To: ALL ISUZU DISTRIBUTORS AND SERVICE DEALERS
Subject: TIER 3 OIL FILTER HOUSING UPDATE

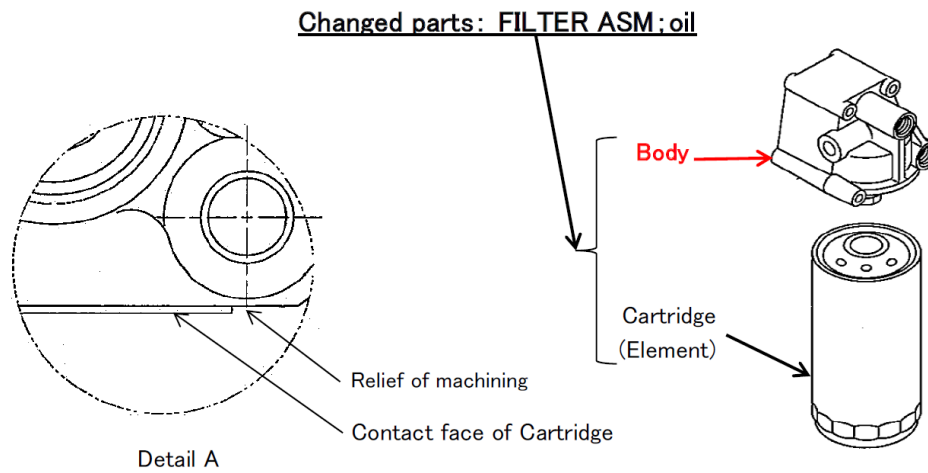
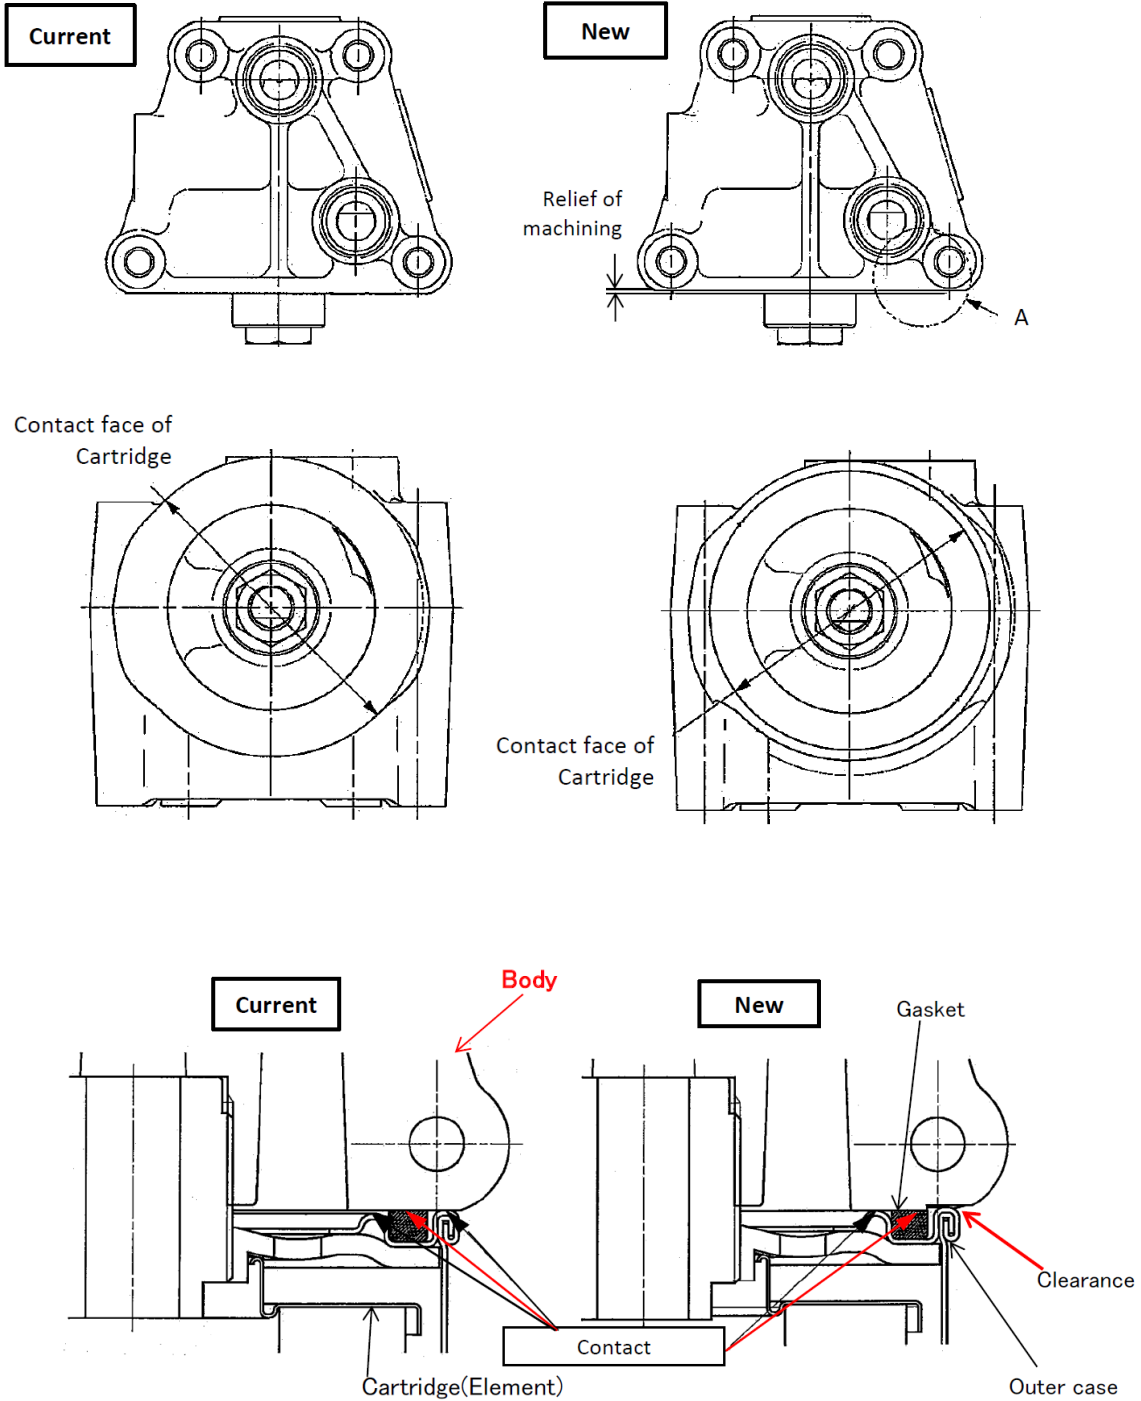
A machined relief has been added to the oil filter housing to allow better filter fitment which allows easier removal of filters during services. Subsequently, the filter housing has changed and now has a new part number. Listed below are the updated part numbers and the list of affected engines.

Mark	Affected Parts	Current Parts	Q'ty	New Parts	Q'ty
A	FILTER ASM ;oil	898735 8630	1	898375 8631	1
B		898375 8660	1	898375 8661	1
